PUBLIC CONSULTATION #2 SUMMARY REPORT

Passmore Avenue Environmental Assessment Study

**Public Consultation Summary
Public Consultation #2 (Online)**

November 2017

TRAFFIC LANES

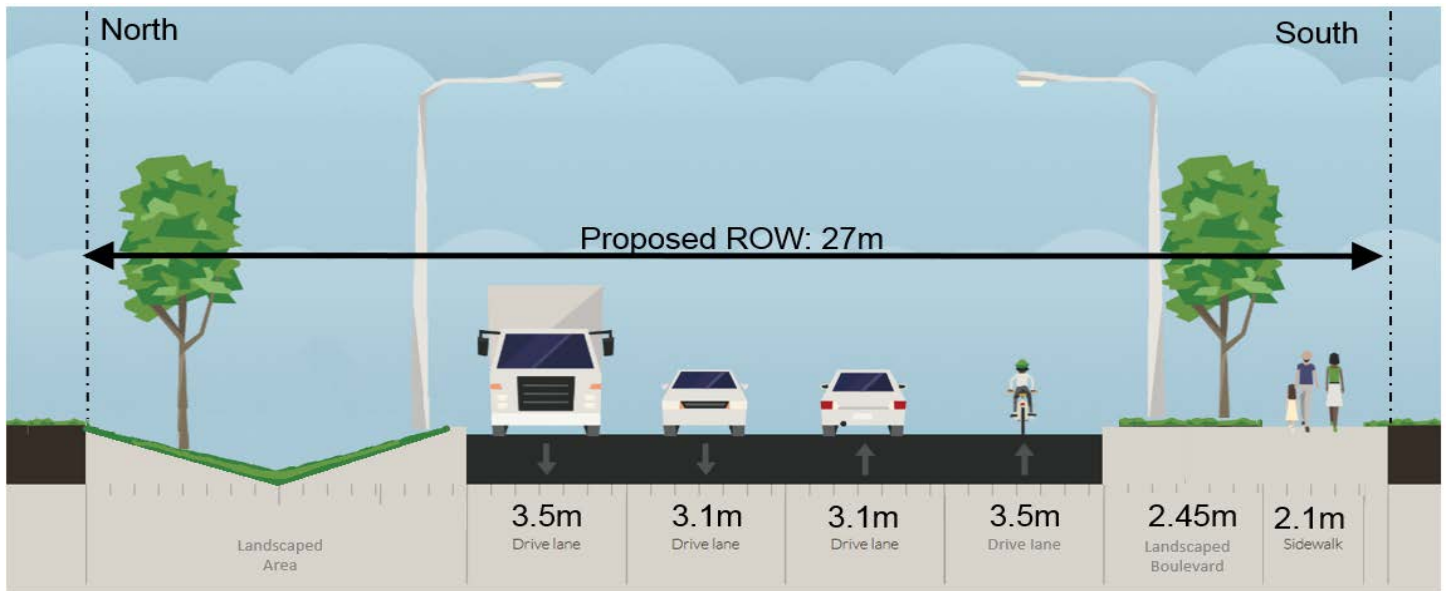
7.	Seems like overkill!
8.	We are supportive of recommendation 4B: 3.5m Curb lanes, 3.1m Through lanes, south sidewalk

#	Total Responses - 9
1.	4B would work efficiently, I understand why it would be preferred. A sidewalk on both sides of the street would be safer for pedestrians, considering cost, I understand why a side walk on one side of the Passmore Ave. is preferred.
2.	No
3.	I prefer the 4A or 4B solution. The sidewalk on both north and south side would be great, but if the south side only on the south is fine to me.
4.	Fully agree
5.	No.
6.	These preferred changes are very welcome . Having lived in the neighbourhood for 36 years it will be nice to see these long-overdue improvements .
7.	no
8.	no
9.	I am indifferent with regards to the traffic lane options but I prefer the sidewalk on the south side only

#	Total Responses - 7
1.	I don't believe more trees are a necessary addition. When not maintained, they will cause more problems. Not putting in trees would be a savings in cost.
2.	No
3.	Fully agree
4.	No.
5.	This plan is the most suitable way to go .
6.	no
7.	Who will maintain the sidewalk in winter? I am concerned about liability issues when the new sidewalk is installed so close to private buildings, especially at 501 Passmore. I do not want to pay extra for maintenance of this new sidewalk.
